**Proposed Wellsite
Sutton's Lane, Great Altcar
Supplementary Transport Statement**

November 2019

PLANNING APPLICATION LCC/2019/0037 – PROPOSED HYDROCARBON EXPLORATION SITE AT SUTTONS LANE, GREAT ALTCAR, FORMBY

Appendix 2 – Swept Path Analysis

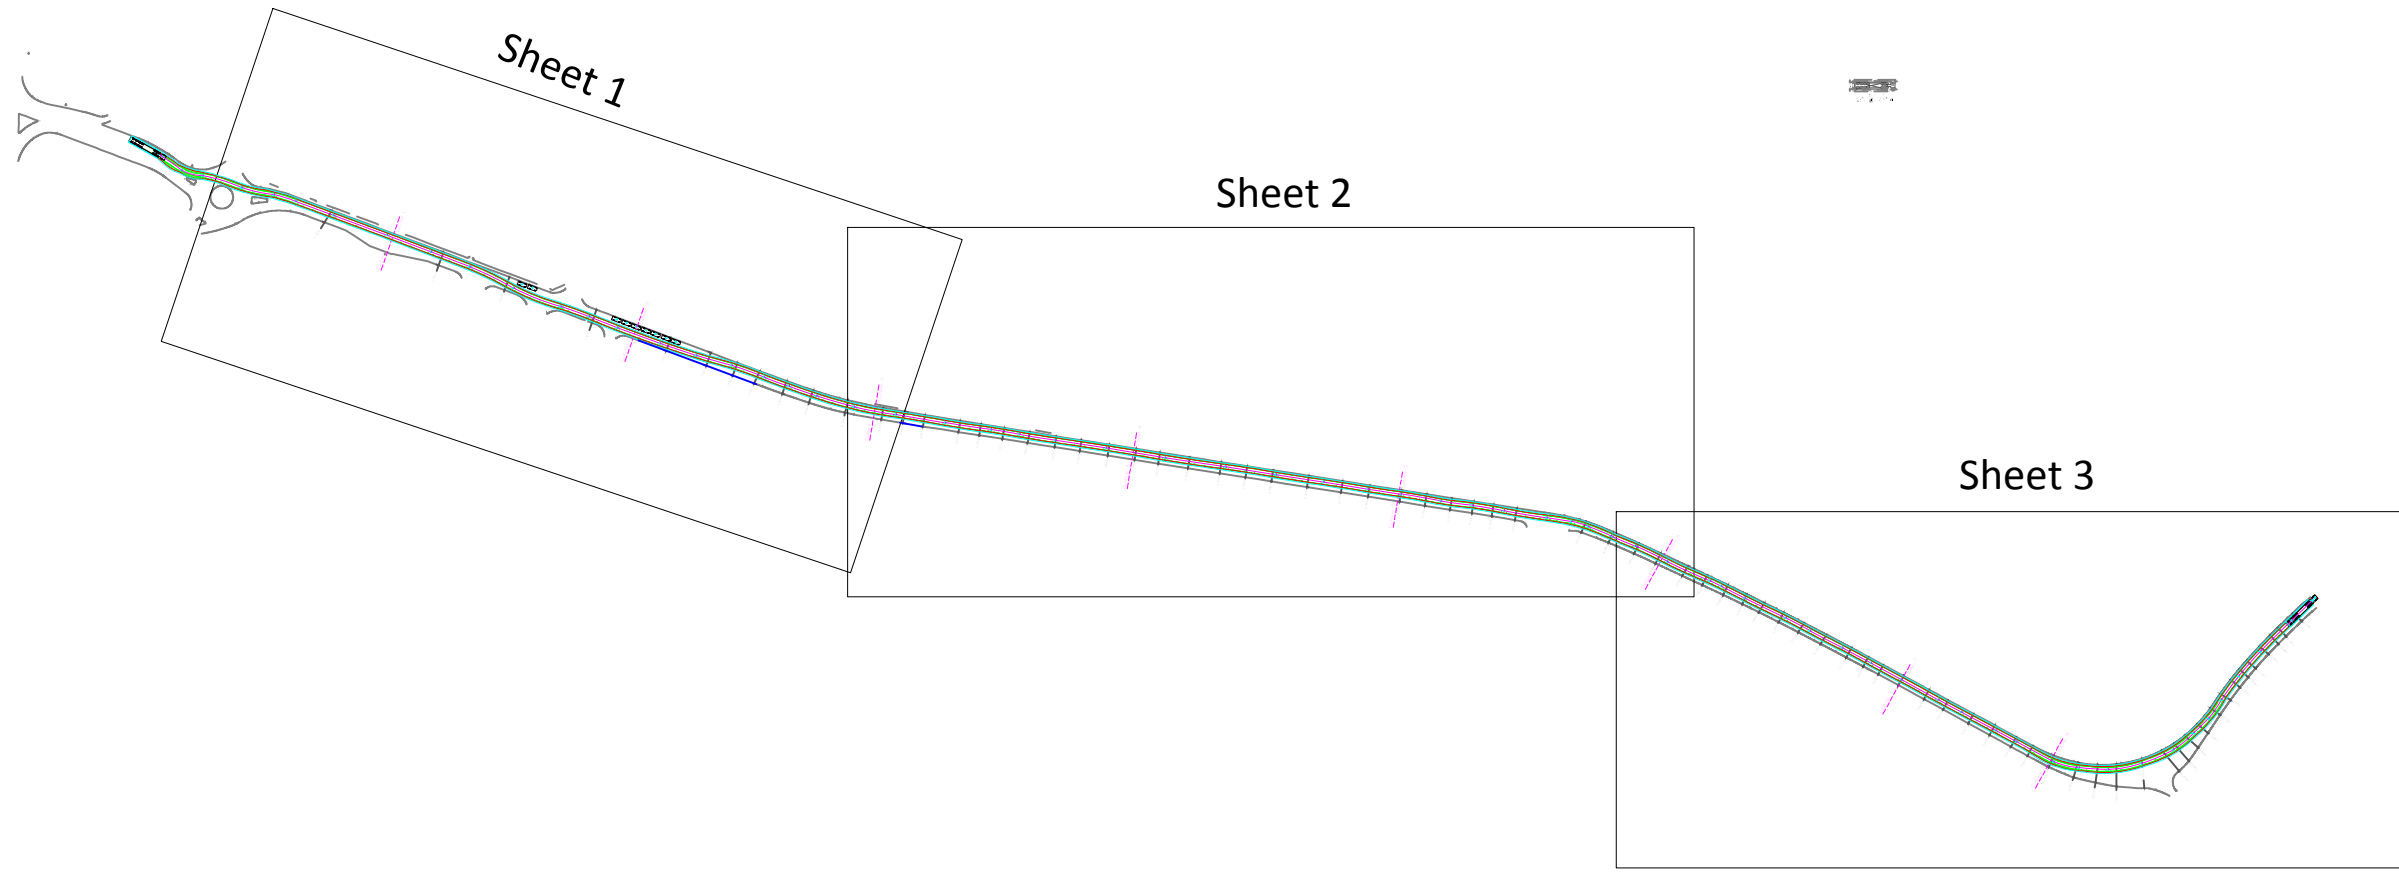
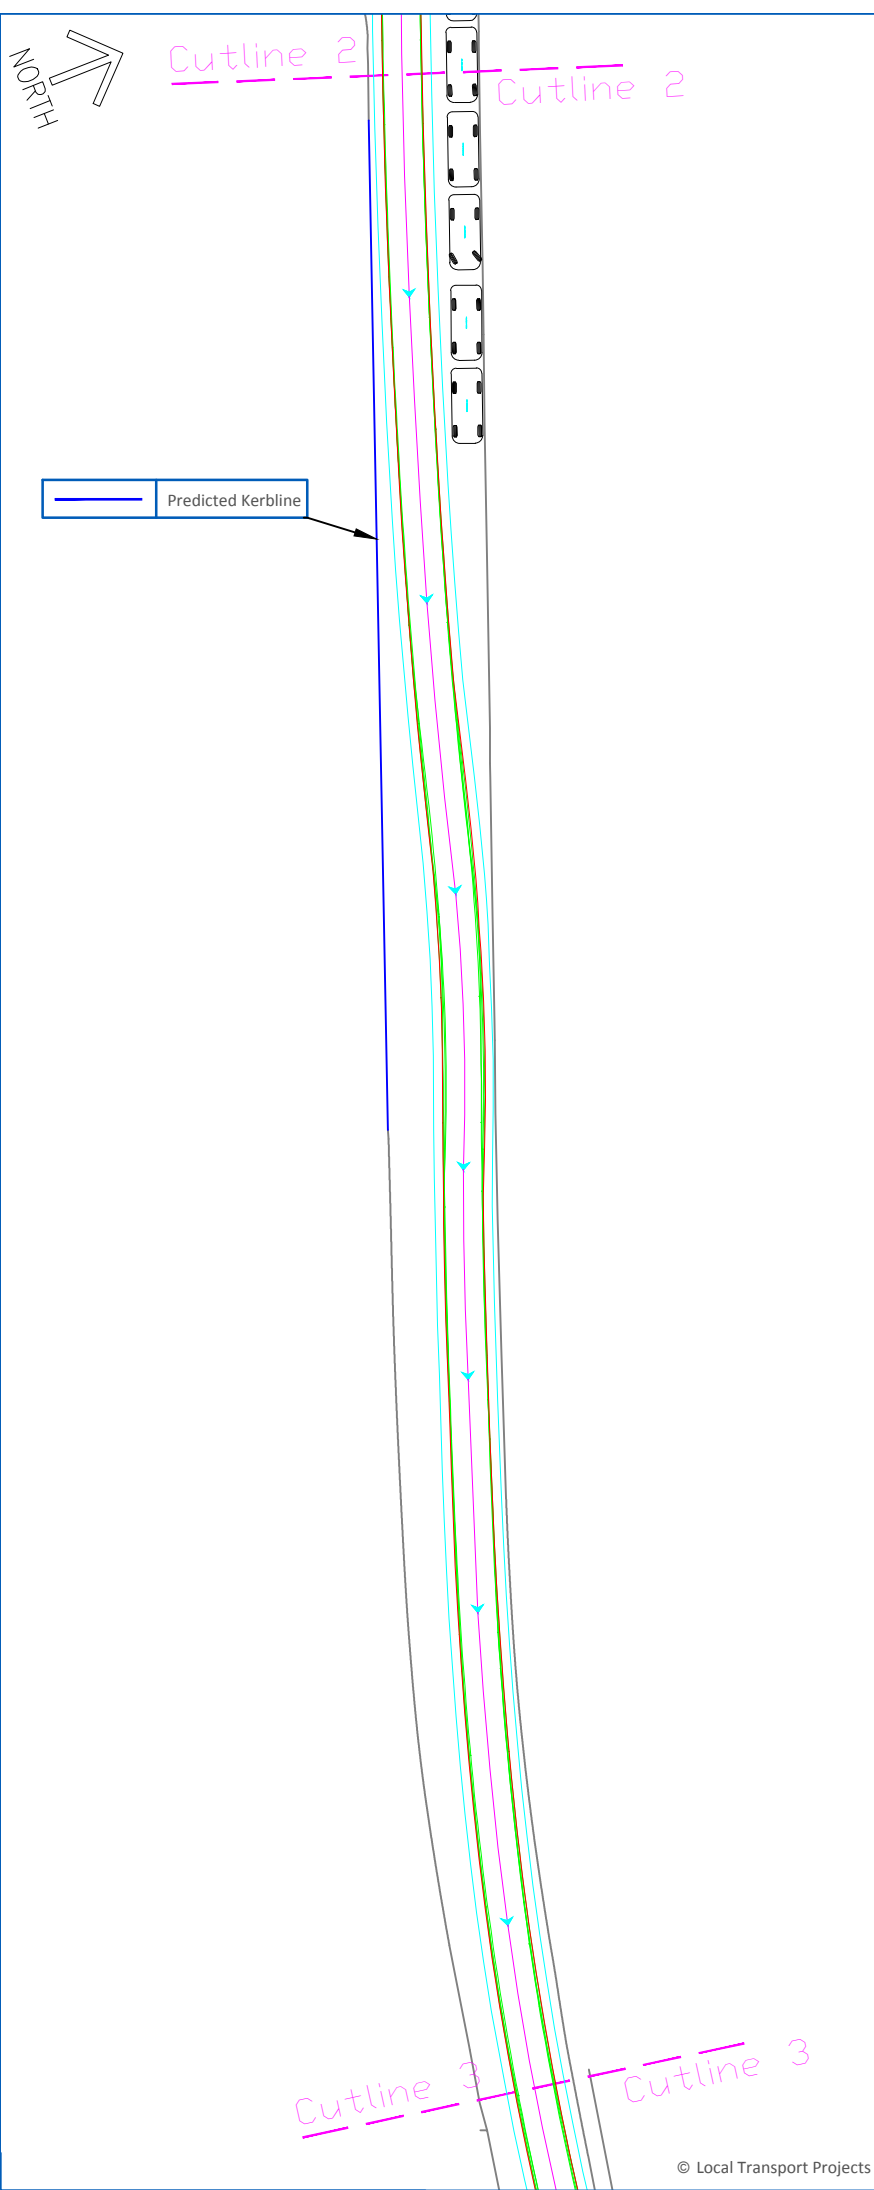
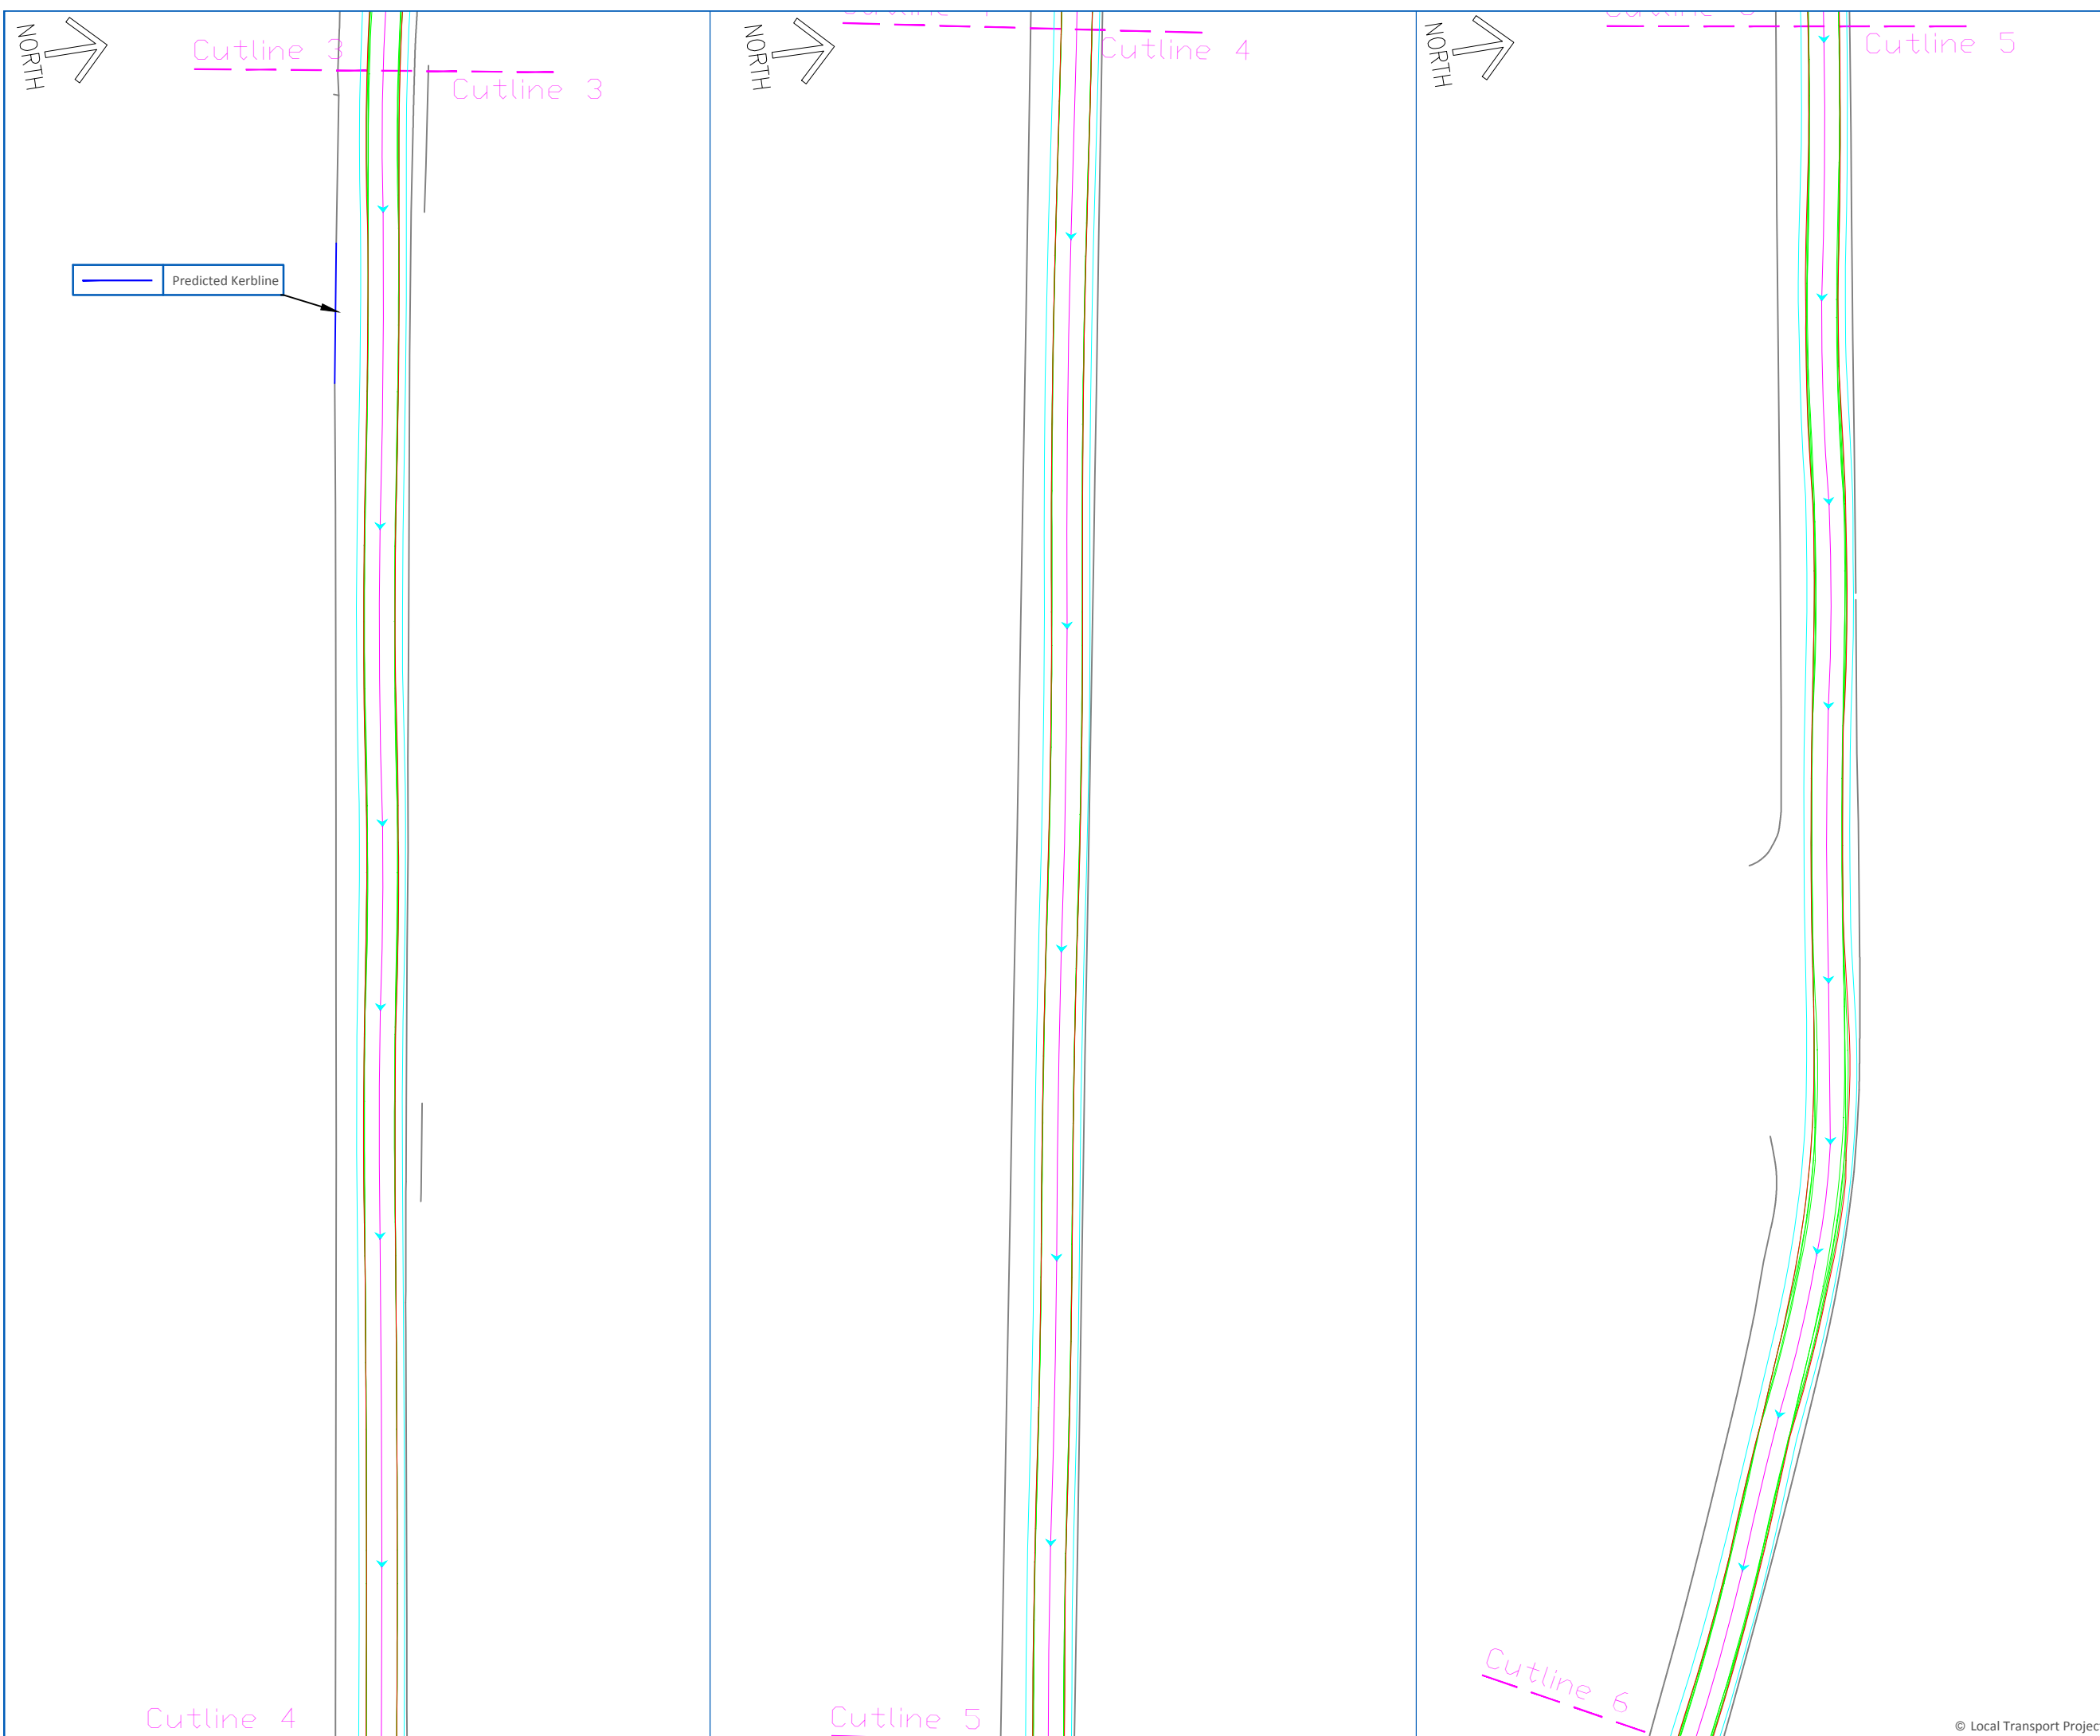
- 4.1.1 **Regulation 25 Request (Appendix 1) – SC Highways:** “Sefton also make comment about abnormal loads in particular the Active Mud Tank Transport. I note that you have included swept path diagrams for this vehicle and Sefton note that this vehicle would have to cross into the opposite carriageway to pass the Altcar Road/Stephenson Way roundabout and would have to cross a bridge on the Sefton/Lancashire boundary. In assessing the highway impacts of this abnormal load, it would be useful to know how often this vehicle would access the site and its total weight. You should also take into account Sefton's observations regarding on street parking but my own observations are that there are 'no parking' restrictions around the Altcar Road/Stephenson Way roundabout which should prevent parking in that particular location.”

- Sefton also make comment about abnormal loads in particular the Active Mud Tank Transport. I note that you have included swept path diagrams for this vehicle and Sefton note that this vehicle would have to cross into the opposite carriageway to pass the Altcar Road/Stephenson Way roundabout and would have to cross a bridge on the

- 4.1.5 The largest vehicle has been identified as the transport for the Active Mud Tank, which will generate two (2) movements, once upon mobilisation of the drilling rig, and then again upon demobilisation of the rig. There are expected to be some movements of smaller abnormal loads, although the number of movements is small, with 20 other parts of the rig that need to be transported to the site upon mobilisation of the rig (and the transported away as part of demobilisation). It is worth noting that the vehicles transporting the abnormal loads will require less/no traffic management before/after the material/equipment is loaded onto the vehicle.

- 4.1.6 It is acknowledged that, even with traffic management, the access routes still need to be wide enough and suitable to accommodate these AILVs. As a principal road, it is expected that the movement of AILVs can be accommodated on the dual carriageway A565 without mitigation (but with suitable traffic management). However, in order to ensure that the access route between the A565 and the site can also accommodate AILV movements, swept path analysis has been undertaken for the largest AILV expected to visit the site. As part of the TS, the proposed delivery route was assessed in order to identify key locations for testing, with only Sutton's Lane and the Altcar Road (B5195)/Stephenson Way roundabout requiring assessment. However, this testing has been extended as part of this STS in order to cover the full route between the A565 and the site, as shown in Appendix 2.

- 4.1.7 This swept path analysis shows that, even the largest AILV, there is no expected overrunning or overhanging beyond the carriageway along the full route, including the section within the SC area. It is acknowledged that, as is the case with a significant proportion of AILV movements, the vehicles would be required to partially cross over the centreline on single carriageway roads, hence the requirement for specific traffic management measures.
